EIA Scoping Direction

DNS CAS-03107-C5X9W1: White House Farm Solar and Storage Facility

14/10/2025

Figure 2: Site Location (Access Route, shown as submitted by Axis)

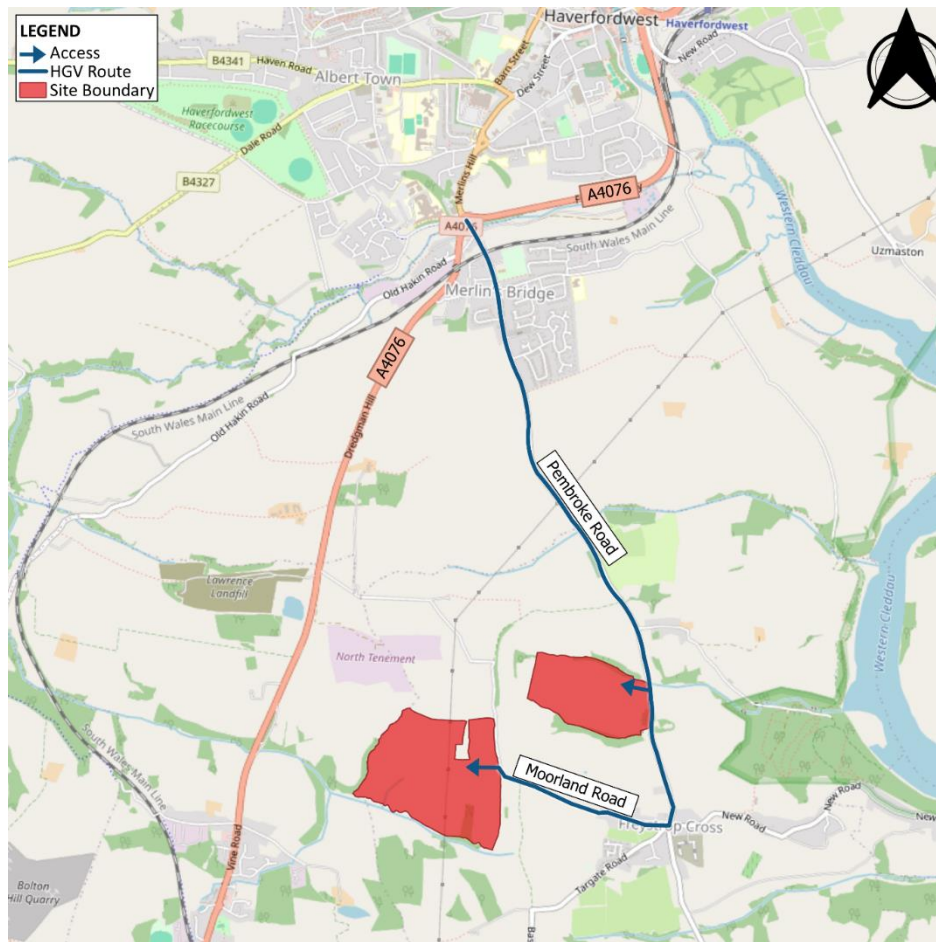
The site plan and pre-planning application statement show that both parcels of land will have a separate access. The southern site will be accessed off narrow and lightly trafficked unclassified public highway (U6071) known as Moorland Road via an extant access point immediately north of White House Farm. The access is approximately 960m west of the junction of U6071/ C3007 (known as Freystrop Cross), the access route is shown in Figure 2 below.

The exact origin of construction related HGV trips is uncertain at this stage and will be determined by the sourcing of materials and plant by the appointed contractor. HGVs will nonetheless be routed primarily along the strategic road network, avoiding residential areas and statutory limits on HGV movements (such as weight restrictions). The preferred route to / from the Site is shown on the HGV route plan illustrated in figure 2.

The western end of Moorland Road past West Priory View dwelling to the application site access narrows considerably to circa 3m wide at its slimmest. There are two formal passing bays along this stretch of road with some additional informal bays located at fields/ residential accesses. The applicants have submitted plans (Drawing No. 5076-ATR01 to ATR05) showing a package of traffic mitigation measures running from Merlins Bridge Roundabout, along Pembroke Road and Moorland Road, which will assist in accommodating the required HGV movements during construction.

Following a review of the plans, the CHA is satisfied with the proposed localised carriageway widening and the inclusion of additional passing bays especially along Moorland Road. The submitted plans also include Swept Path Analysis for HGVs

which, is deemed suitable. Detailed plans of any new/improved passing bays should be submitted with any forthcoming application, including passing bays a minimum of 12m in length with splays, surface details to be provided and any draining/culverting details as required.

Annex 2. - Predictive ALC Map (2019) for the proposed site.

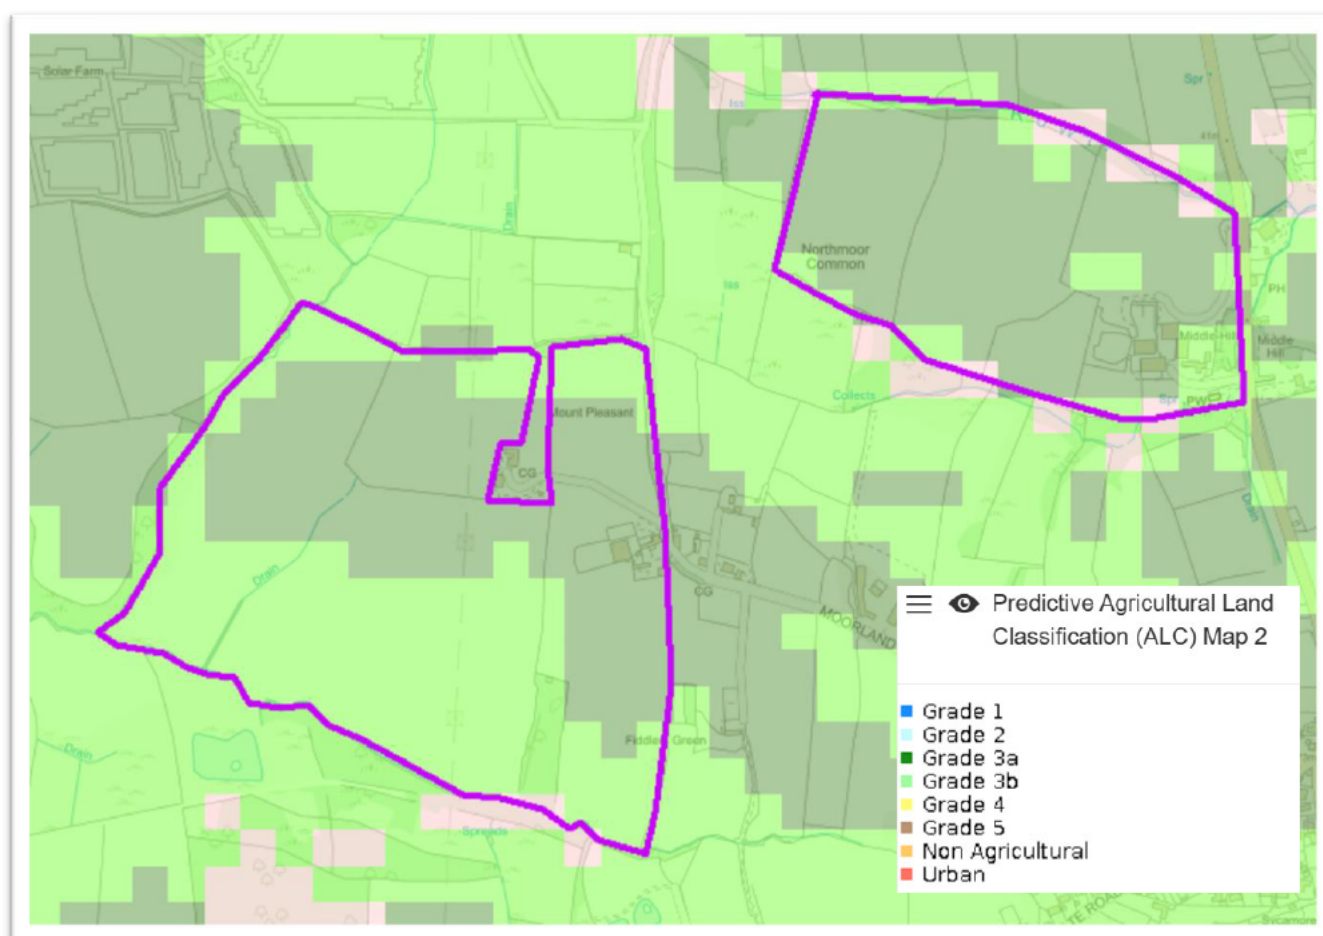
The ALC report covers approx. 52ha of agricultural land. The site is noted as being predicted to contain approx. 30ha of BMV agricultural land according to the Predictive ALC Map for Wales. In line with published guidance, planning applications must be supported by detailed ALC field survey evidence where BMV agricultural land is an issue for consideration.
